# MEMO

**To:** Kristopher Byrd, Well Construction and Compliance Section Manager  
**From:** Travis Kelly, Well Construction Program Coordinator  
**Subject:** Review of Water Right Application G-19002  
**Date:** December 11, 2020

# Groundwater Application Review Summary Form

Application # G- 19002

MARI 2890  
 Steve Coleman - Gary Baker  
 Cable Tool Drilled Well  
 as proposed to be  
 Completed July 26, 1982

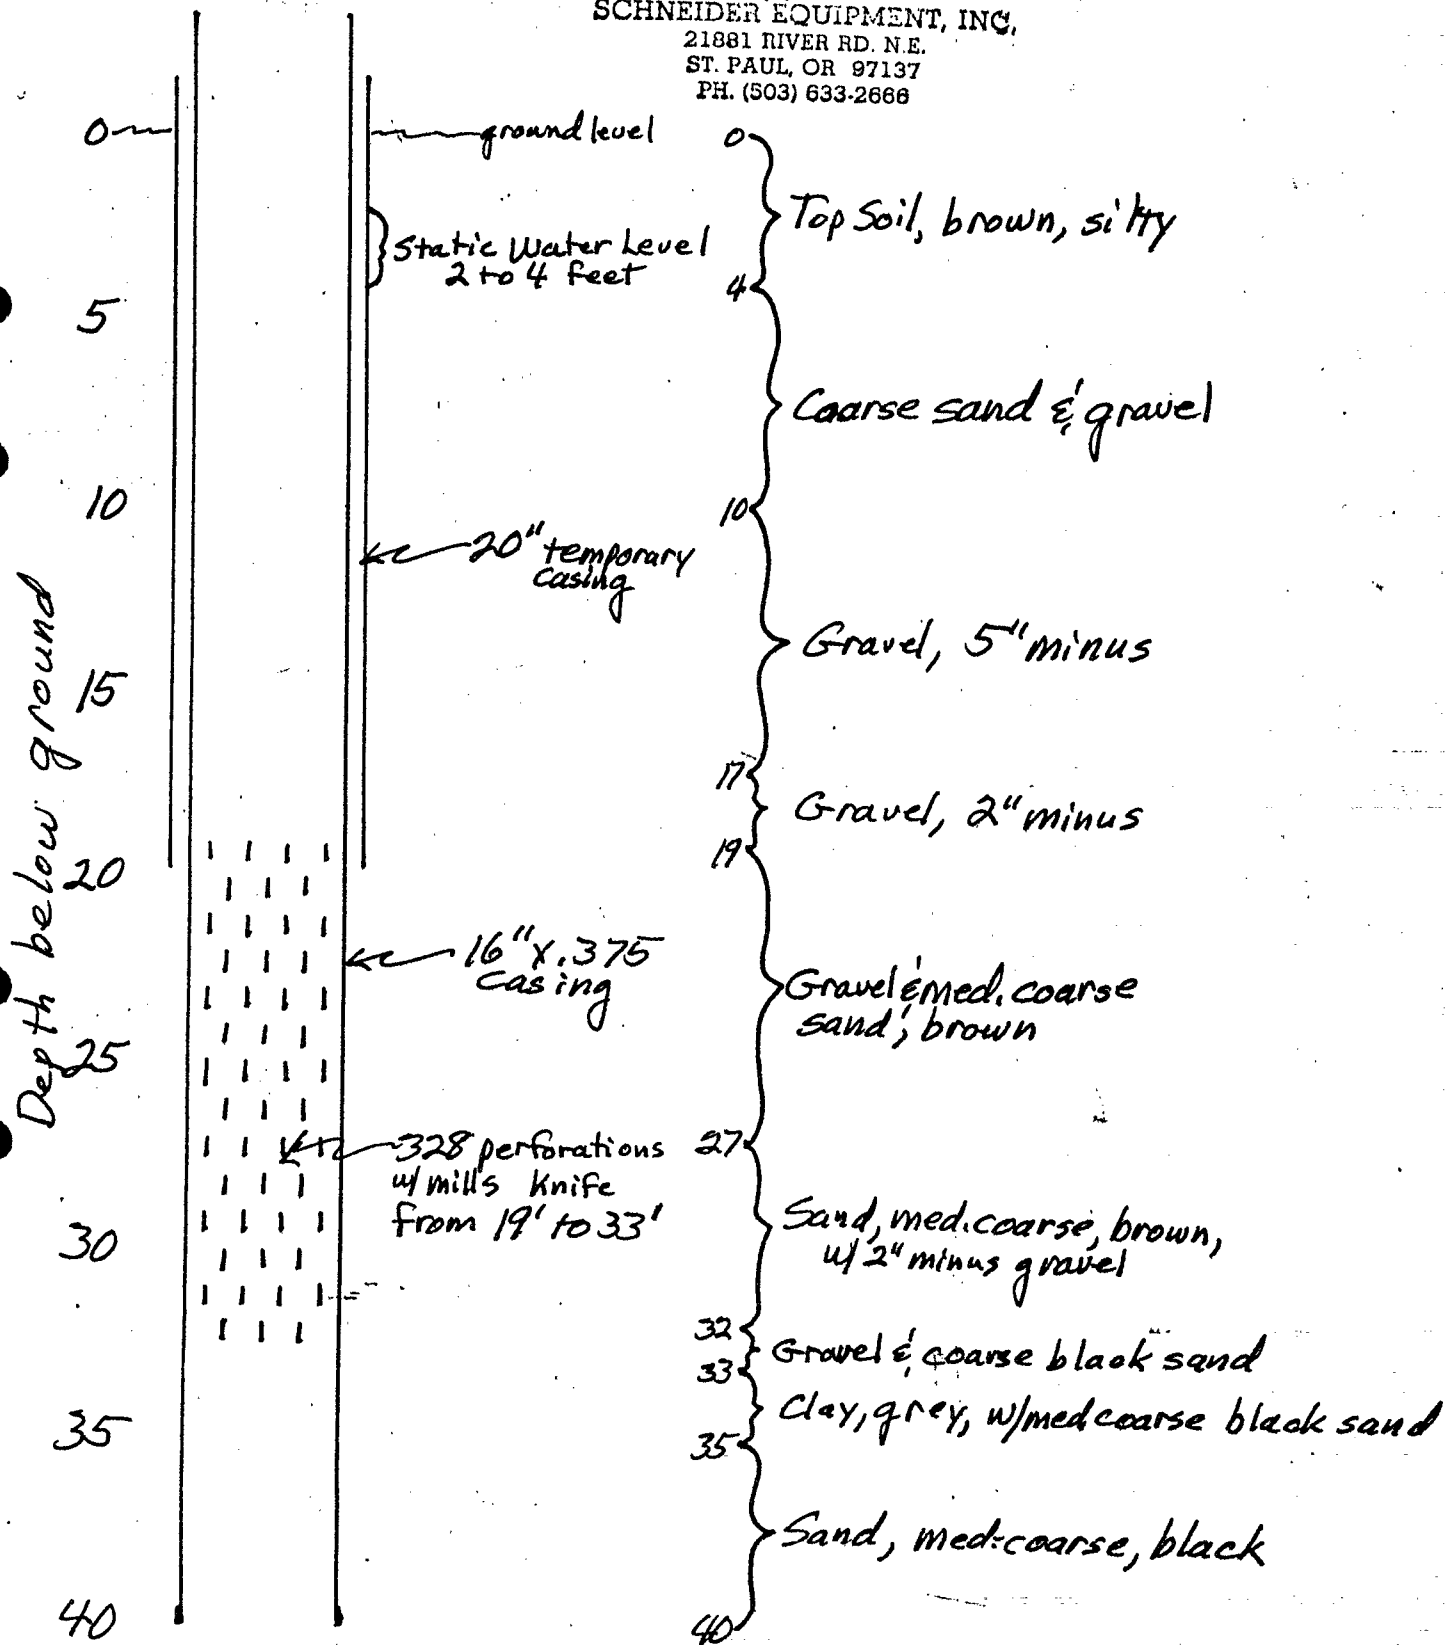
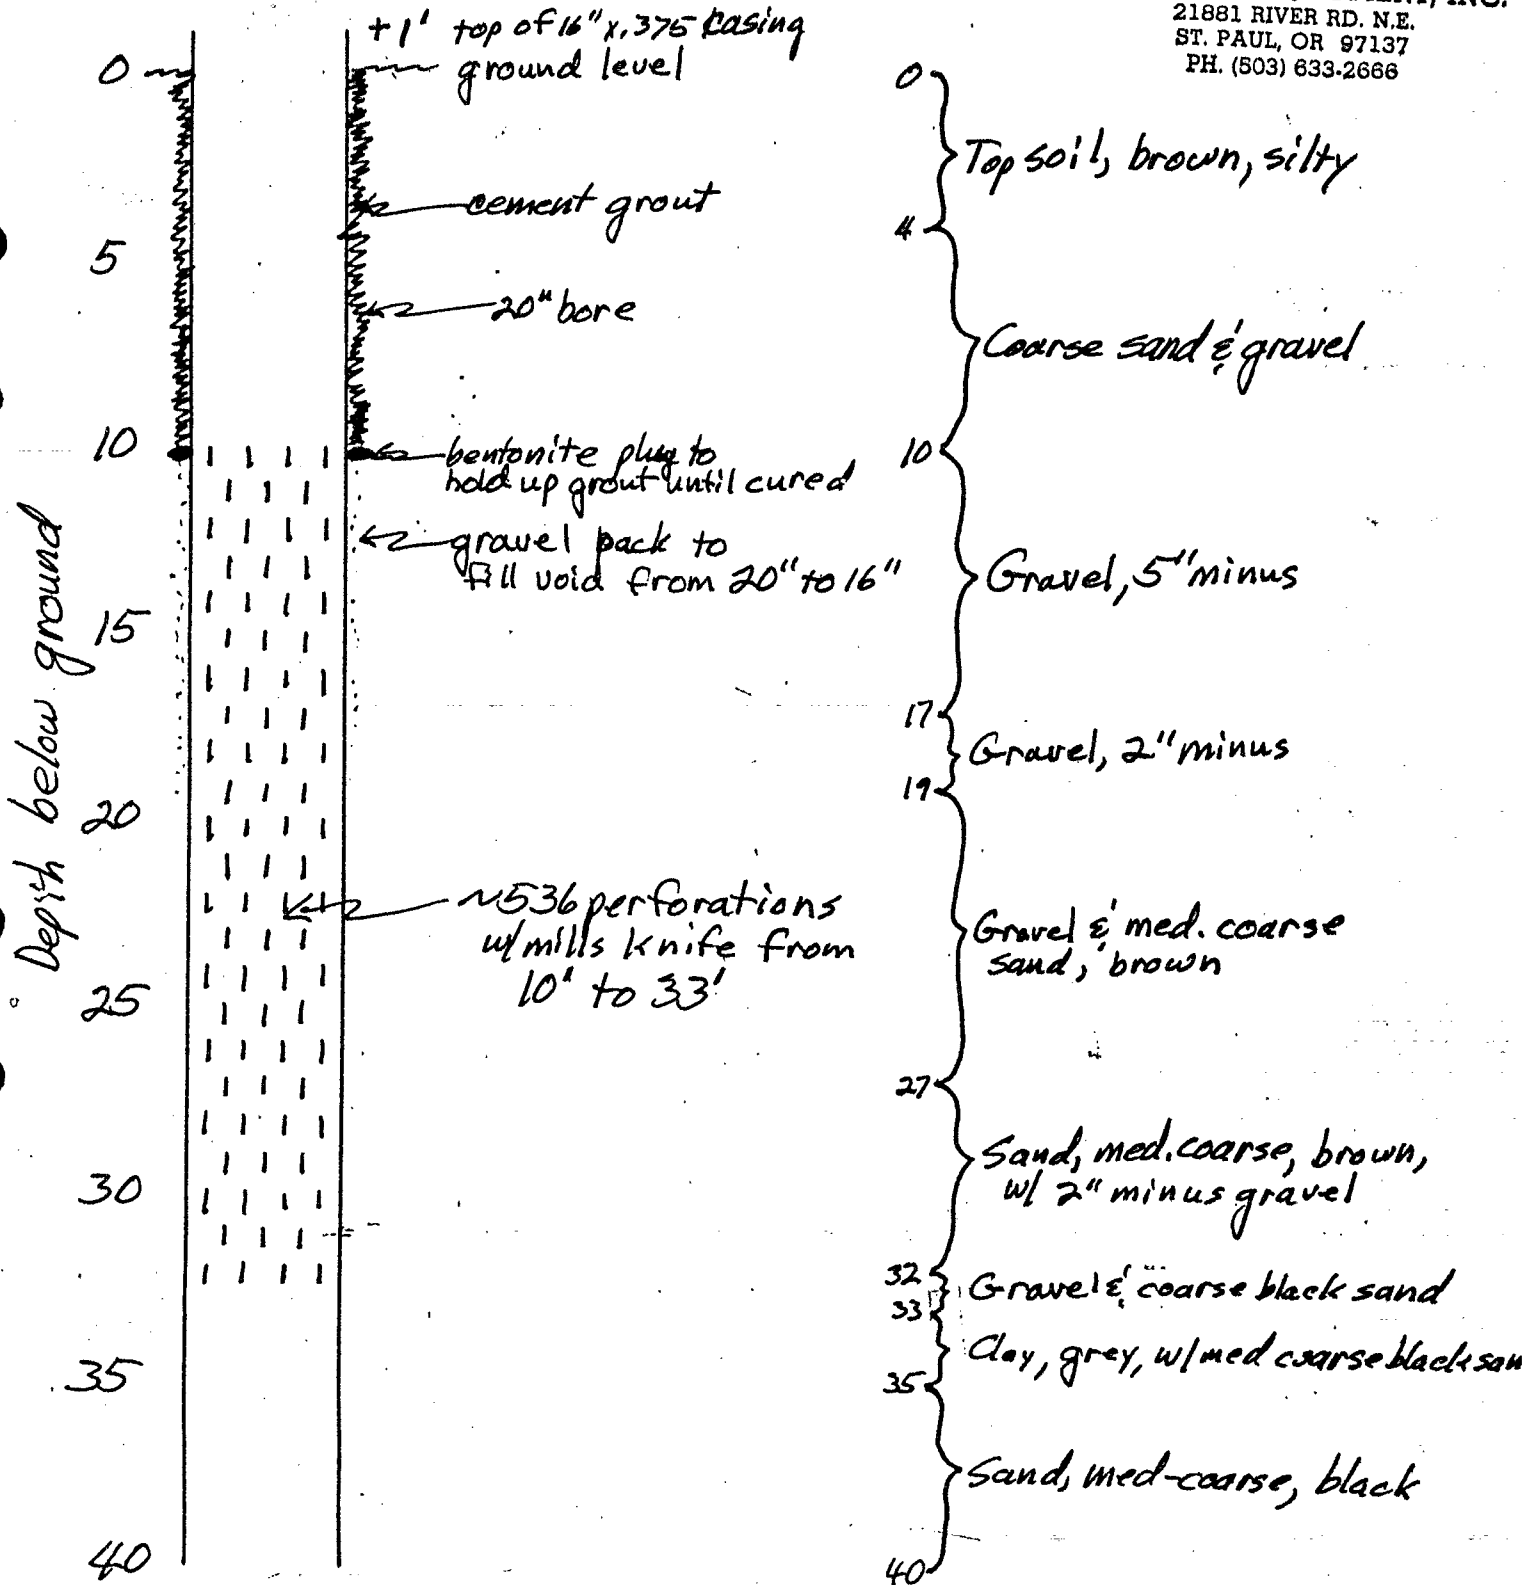
Applicant's Well #3 (MARI 2890): Based on a review of the Well Report and the approved special standard, Applicant's Well #3 seems to protect the groundwater resource.

The construction of Applicant's Well #3 may not satisfy hydraulic connection issues.

Given the condition described in the letter, it is acceptable to seal this well to five feet below the mean summer flow of the Willamette, or 10 feet from land surface.
